MWO 9-2320-272-20-6

### FUEL TANK VENTILATION KIT MODIFICATION WORK ORDER

#### MODIFICATION OF 5-TON M939 AND M939A1 SERIES TRUCKS

1 February 1996

FIGURE 8

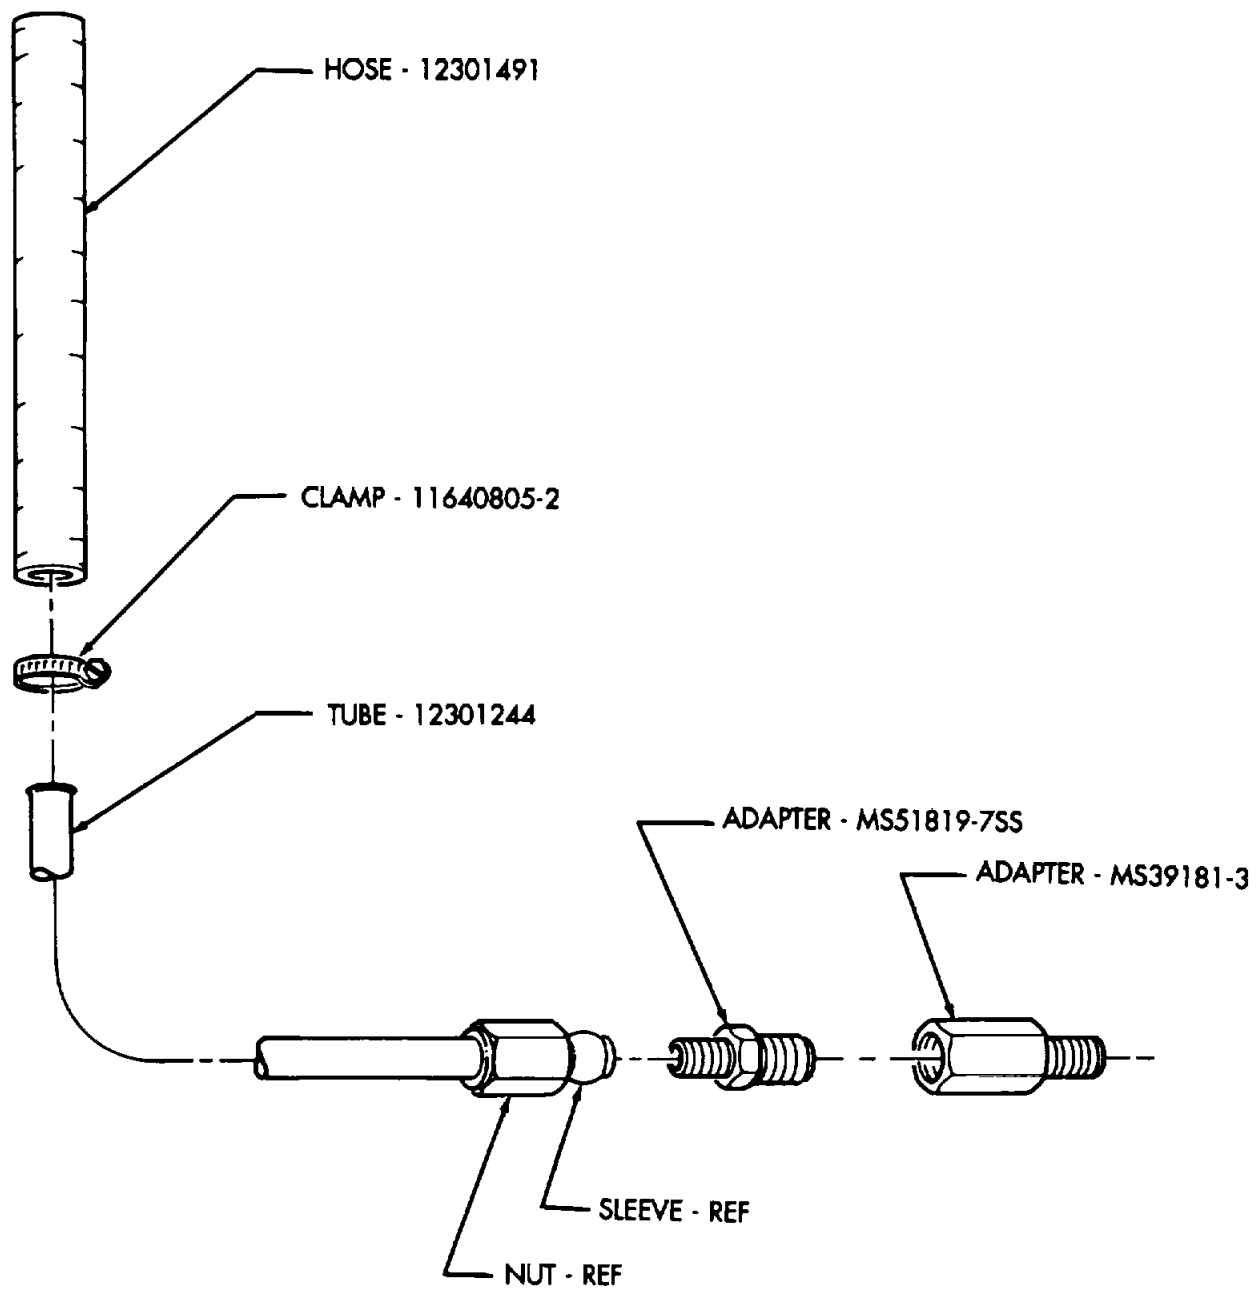
- (9) Install nut, sleeve, and MS51819-7SS adapter on 12301244 tube as shown in figure 8.
- (10) Install tube and adapter on MS39181-3 adapter as shown in figure 8. Retain sleeve and nut for use in step 12.

- (11) Install 12301491 hose on tube with 11640805-2 clamp as shown in figure 8.
- (12) Install two nuts and sleeves from adapters removed in steps 8 and 10 on CPR104420-2 tubing as shown in figure 9.

FIGURE 9

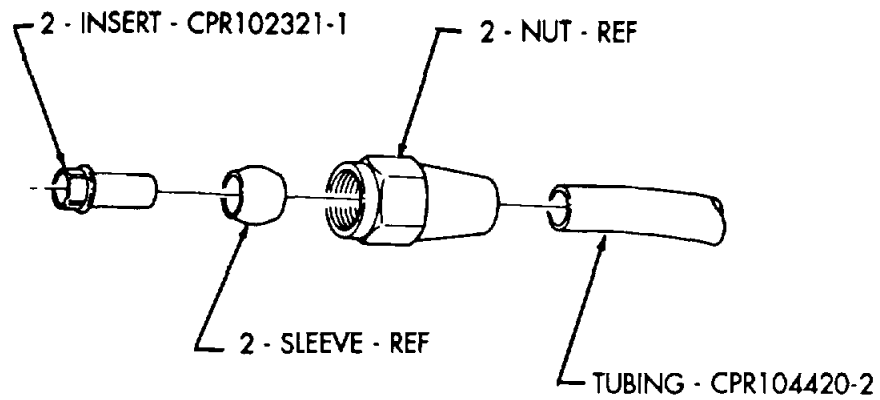
- (13) Install CPR102321-1 inserts in each end of fuel tank vent line as shown in figure 9.

FIGURE 10

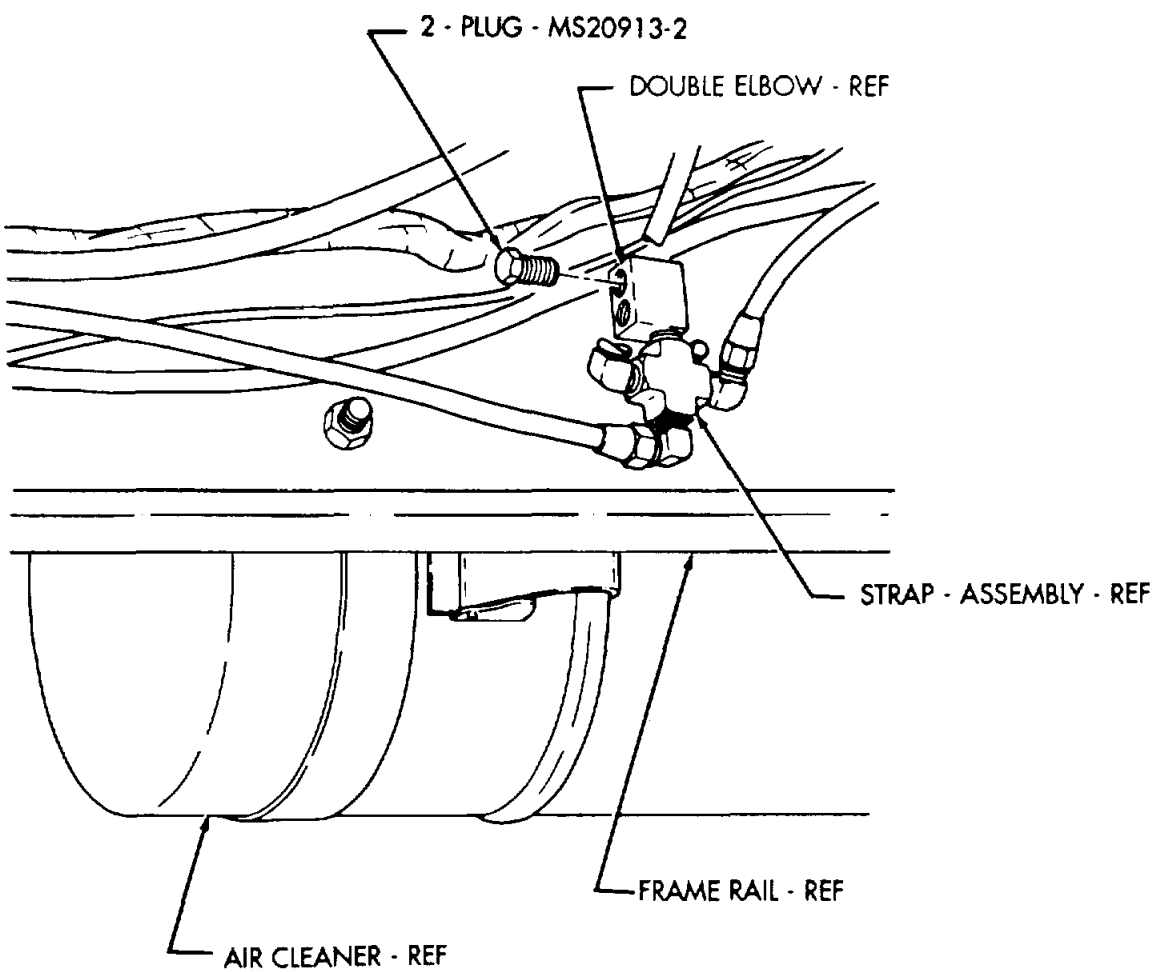
- (1) Install two MS20913-2 plugs in double elbow on strap assembly located inside of frame rail opposite air cleaner as shown in figure 10.
- (2) Install tee assembly on frame rail with MS90726-114 screw and MS51943-40 nut as shown in figures 6 or 7.

FIGURE 11  
18

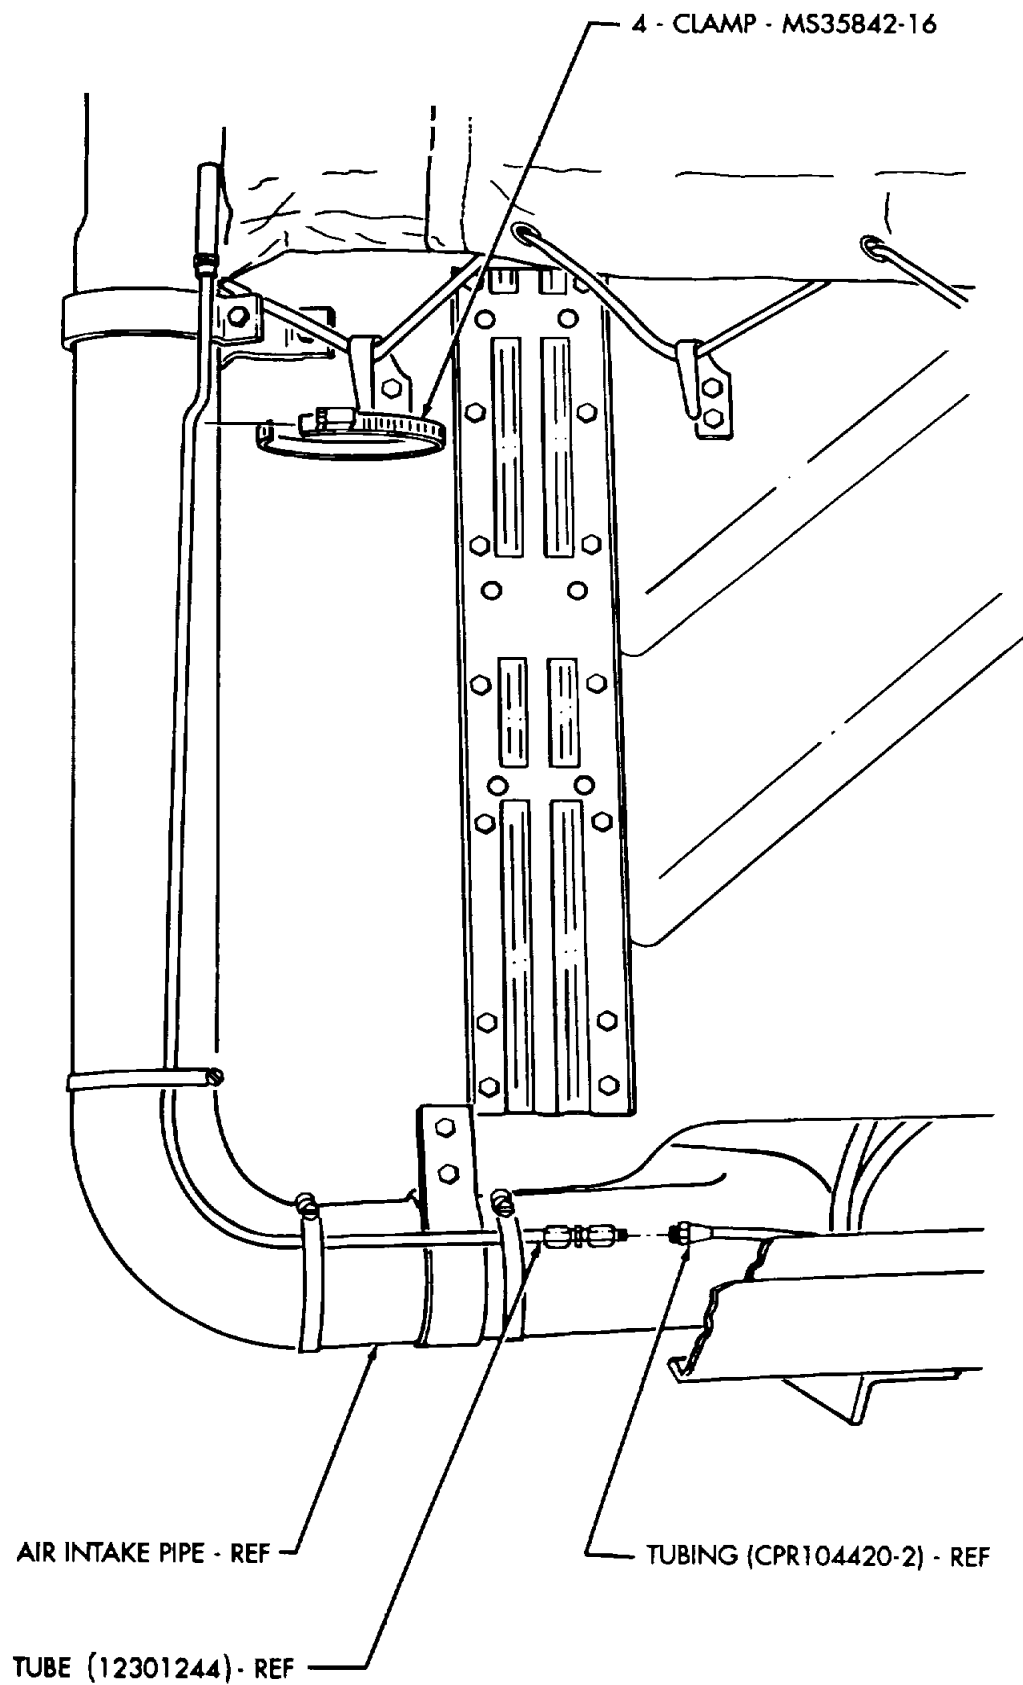
- (3) Connect two fuel tank vent lines from fuel tank-to-tee assembly as shown in figure 6.
- (4) Connect four fuel tank vent lines from fuel tanks-to-tee assembly as shown in figure 7.
- (5) Connect end of CPR104420-2 fuel tank vent line to tee assembly (12301228) as shown in figures 6 or 7.
- (6) Install tube (12301244) on air intake pipe with four MS35842-16 clamps as shown in figure 11. Remove excess clamp ends.
- (7) Connect end of fuel tank vent tubing (CPR104420-2) to tube (12301244) as shown in figure 11.

FIGURE 12

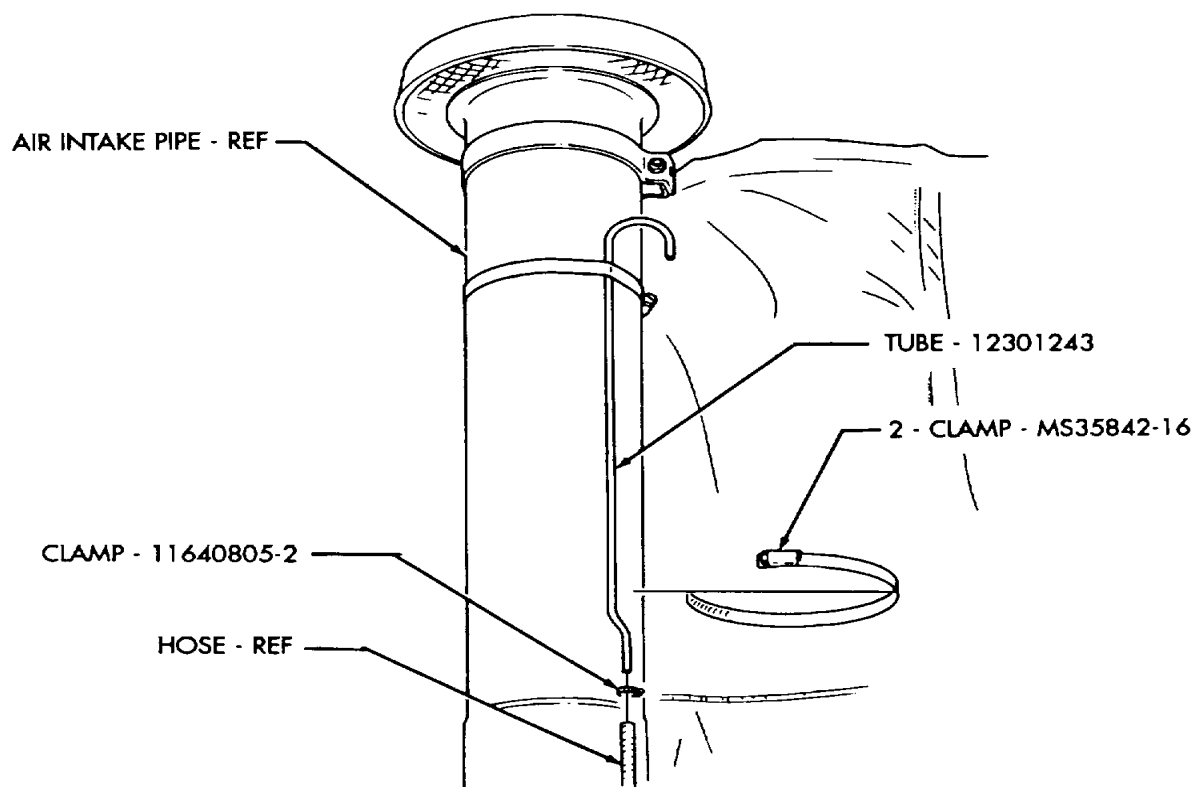
- (8) Install 12301243 tube on hose with 11640805-2 clamp as shown in figure 12.
- (9) Install tube on air intake pipe with two MS35842-16 clamps as shown in figure 12. Remove excess clamp ends.

FIGURE 13

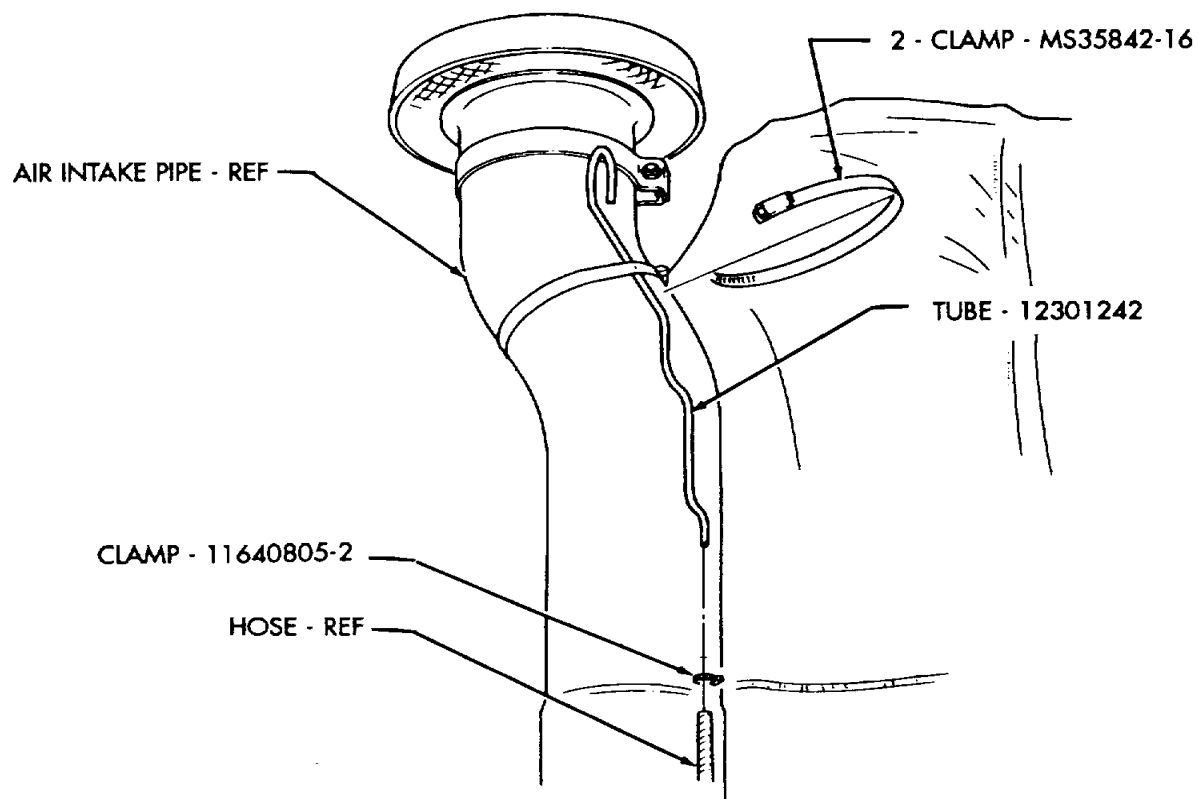
- (10) Install 12301242 tube on hose with 11640805-2 clamp as shown in figure 13.
- (11) Install tube on air intake pipe with two MS35842-16 clamps as shown in figure 13. Remove excess clamp ends.

FIGURE 14

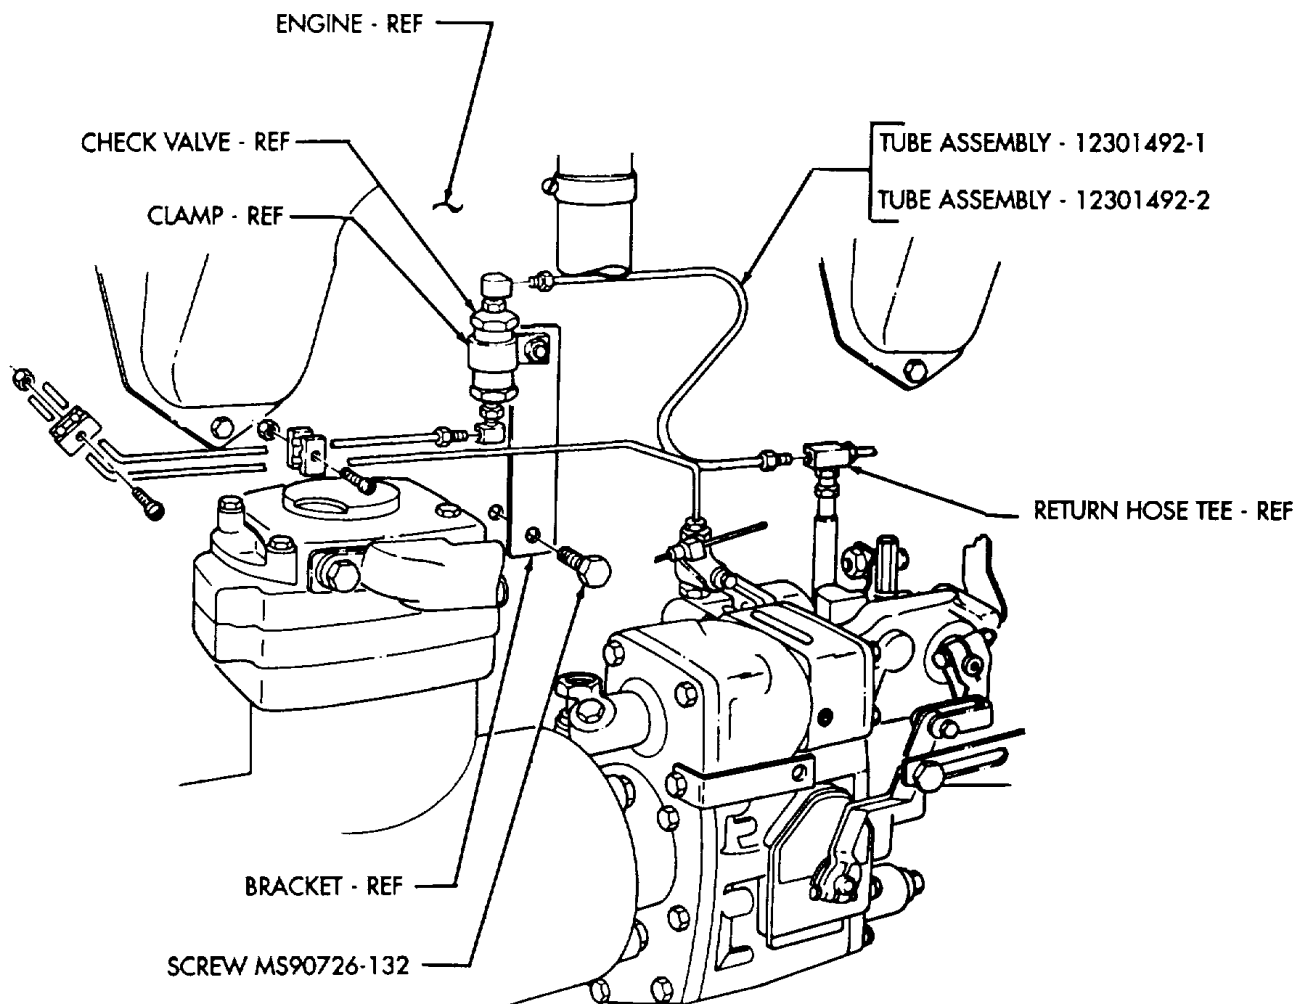
- (1) Install bracket with check valve on engine with MS90726-132 screw as shown in figure 14.

- (2) Connect 12301492-2 tube assembly to check valve and fuel return hose tee as shown in figure 14.
- (3) Connect 12301492-1 tube assembly to check valve and fuel return hose tee as shown in figure 14.
- (4) Connect 12301493 tube assembly to elbow on front of engine and check valve as shown in figure 15.
- (5) Install two clamps on tube assembly and fuel supply line with two screws and nuts as shown in figure 15.

FIGURE 16

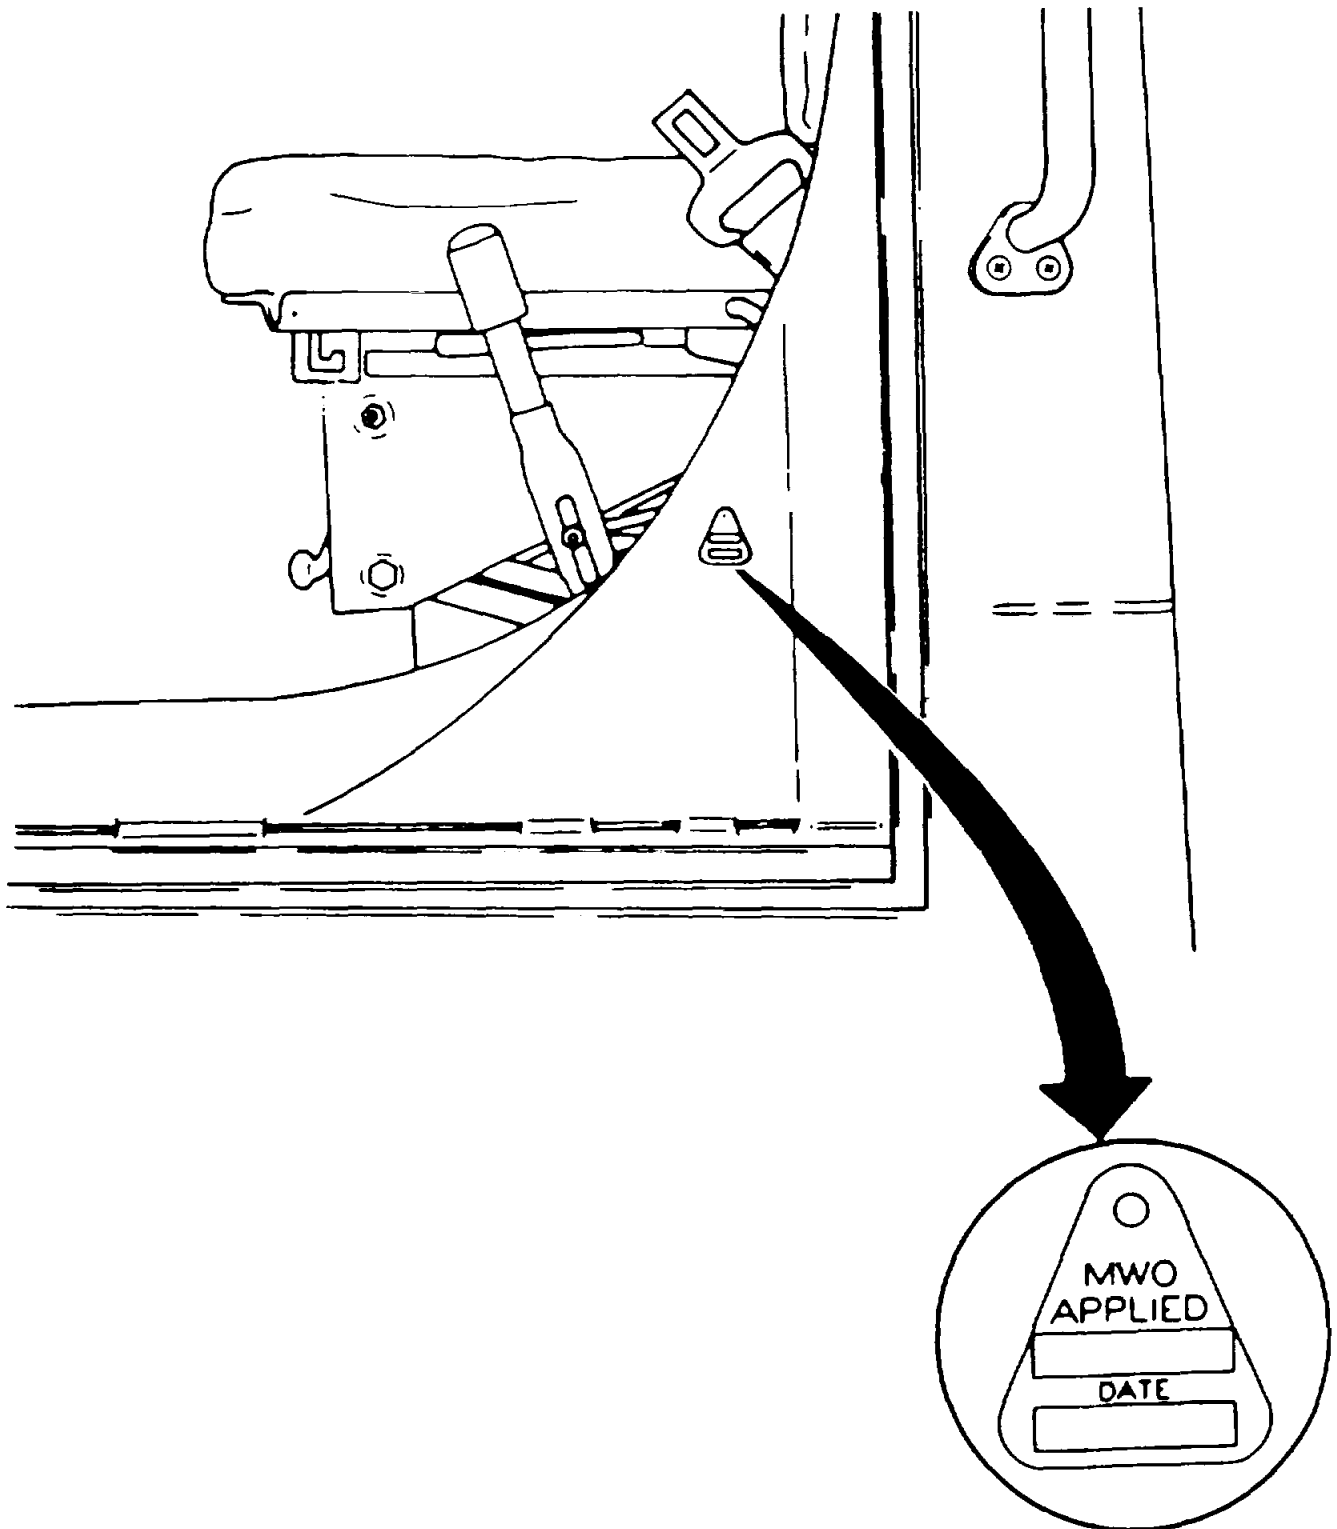
- (1) After Fuel Tank Atmospheric Vent System Kit is installed, mark MWO number "9-2320-272-20 6" in the MWO applied block and date applied in date block on MWO Instruction Plate NSN 9905-00-858-5682.
- (2) Install MWO data plate by drilling a hole (#37 drill) in cab body reinforcement panel and secure with drivescrew NSN 5305-00-253-5614 as shown in figure 16.
- (3) After drivescrew is installed, flatten or remove protruding excess drivescrew material from inside of cab body reinforcement panel.

When the Fuel Tank Atmospheric Vent System Kit is installed, it will be identified by the MWO Instruction Plate mounted on the cab body reinforcement panel as shown in figure 16.
